Source: T1

Title: CR's to TS 34.121 v3.9.0 for approval

Document for: Approval

This document contains 33 CRs to TS 34.121 v3.9.0. These CRs have been agreed by T1 and are put forward to TSG T for approval.

Figure 5.4.2.4 Inner Loop Power Control Test Steps

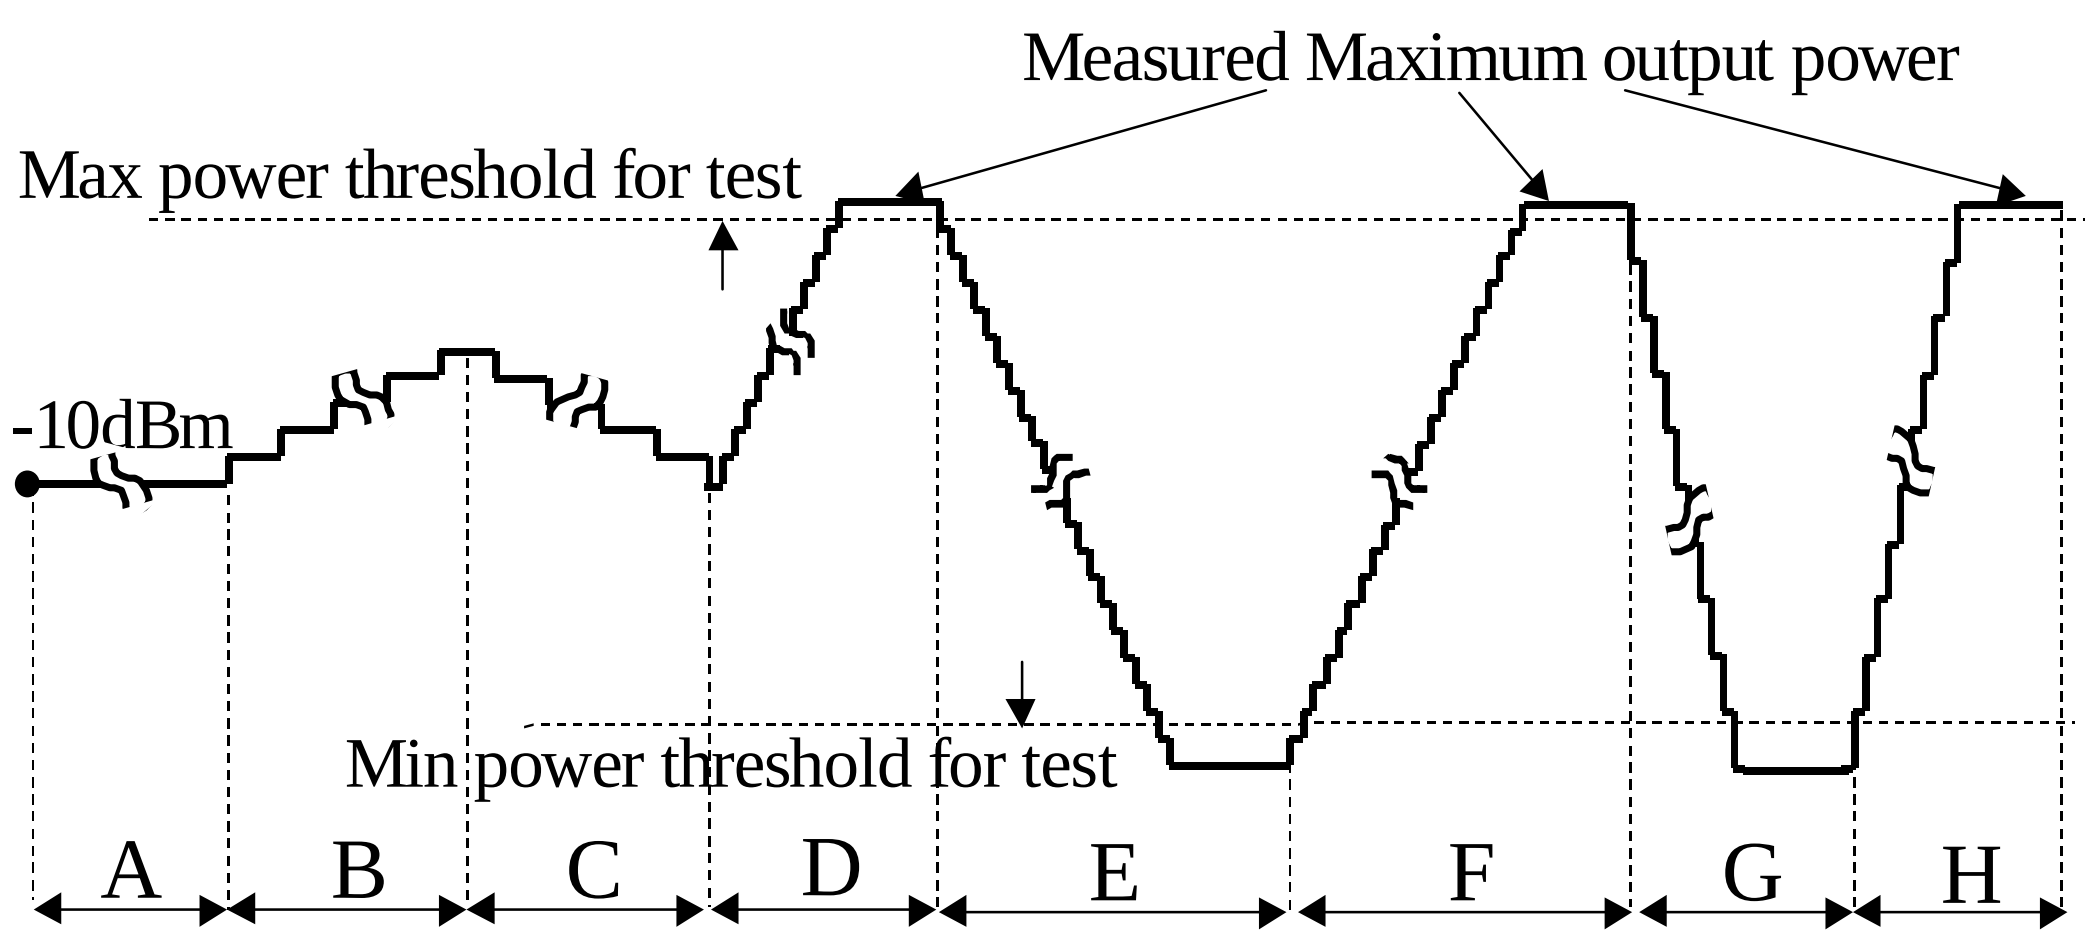
34.121	204	-	R99	Tx Power level control during Rx testing	F	3.9.0	3.10.0	T1-020482
34.121	206	-	R99	Correction to clause 8.3.5 Cell Re-selection in CELL_FACH	F	3.9.0	3.10.0	T1-020484

NOTE-1: These numbers of TPC commands are given as examples. The actual number of TPC commands transmitted in these steps shall be at least 10 more than the number required to ensure that the UE reaches the relevant maximum or minimum power threshold in each step, as shown in figure 5.4.2.4.

~~**Figure F.6.1.9**~~

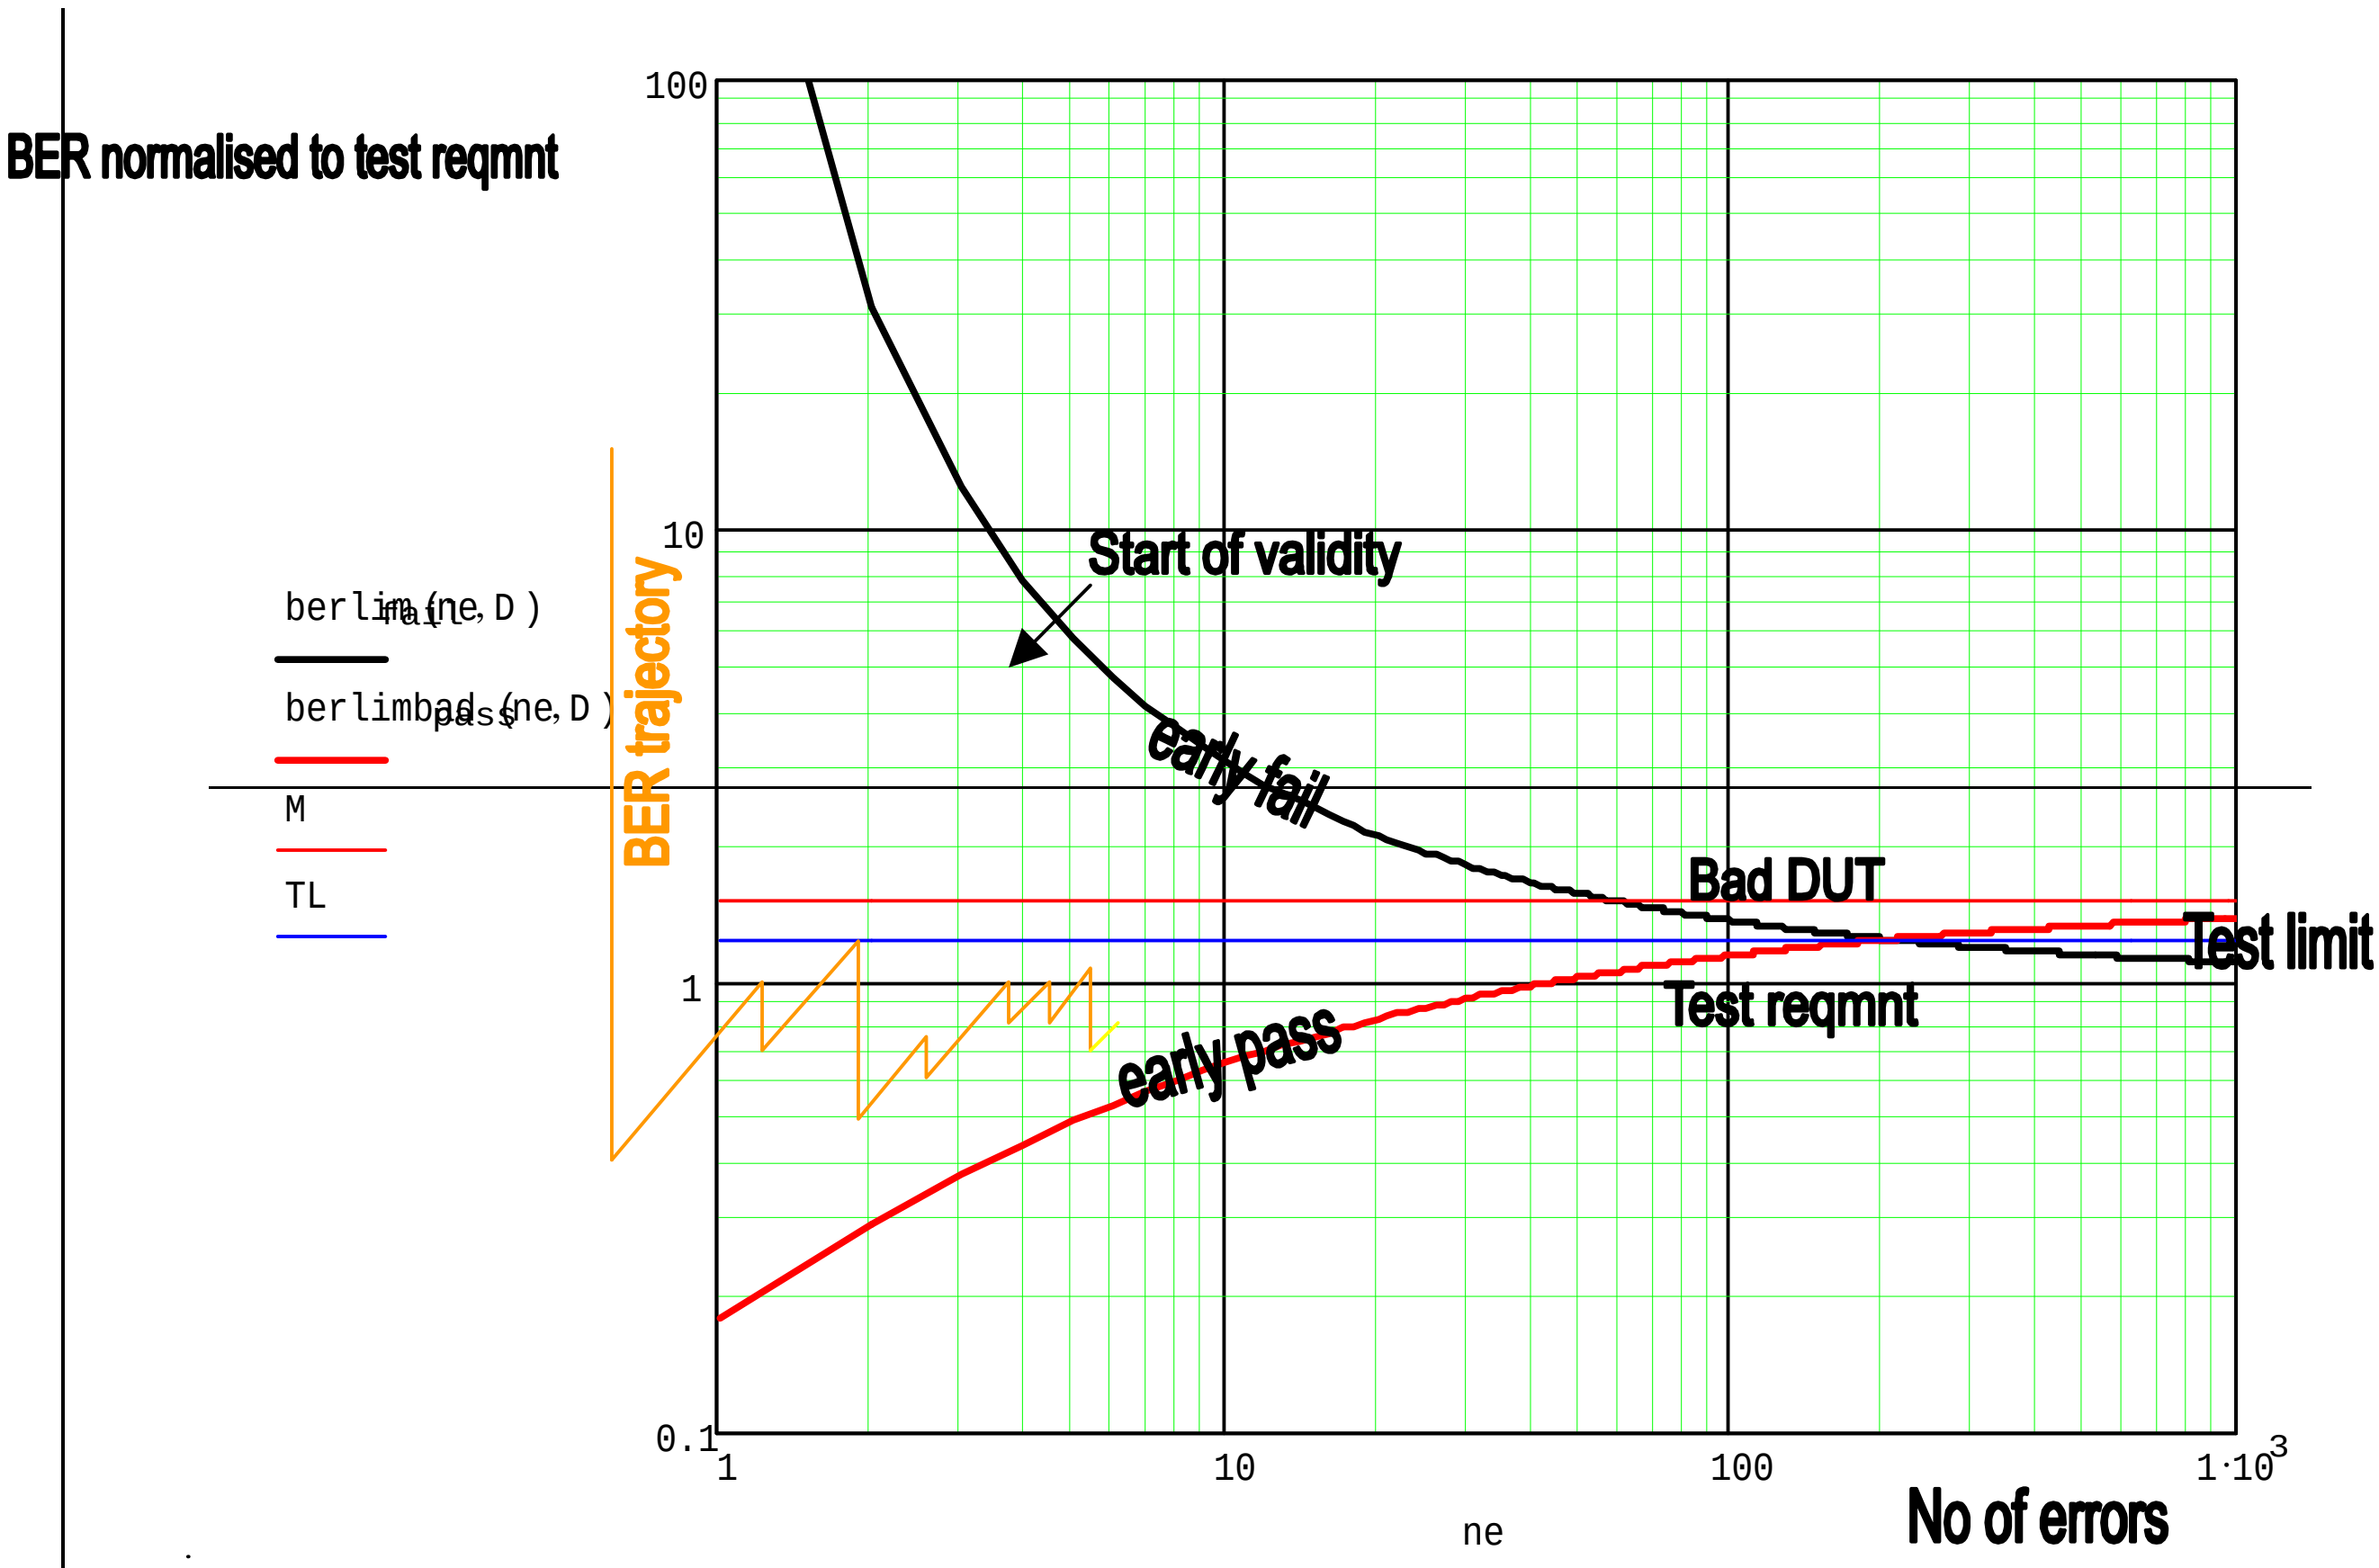
TBD~~See figure F.6.1.9:~~

~~Note 1: At the beginning of the test, an artificial error is introduced. This ensures that an ideal DUT meets the valid range of the early pass limit. In addition this ensures that the complementary experiment (F.6.1.4. bullet point (2)) is applicable as well.~~
